CHILDREN'S HOSPITAL  
OF ORANGE COUNTY

TOWER II

ROOF LEVEL PH1  
REFLECTED CEILING PLAN  
AREA - A

A4.8A

A6 AREA A  
1/8" = 1'-0"

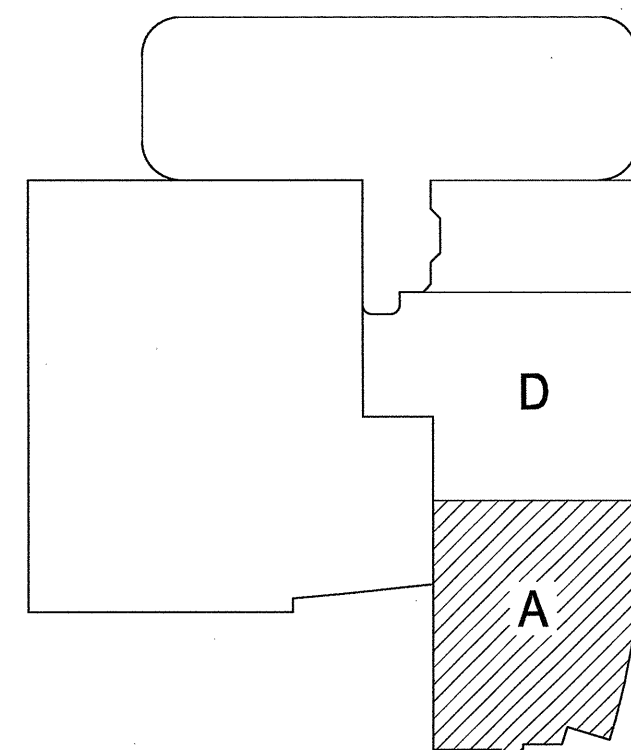
RFI 4175  
Gyp board to be finish  
for soffits reference

RFI 4495  
See detail E5/A8.1 for  
alignment of soffit with  
exterior metal panels

RFI 4665  
No concrete deck  
above. See detail to  
use in lieu of B3/A10.1

RFI 4972  
Provide soffit 1" below ceiling  
Ceiling height adjusted
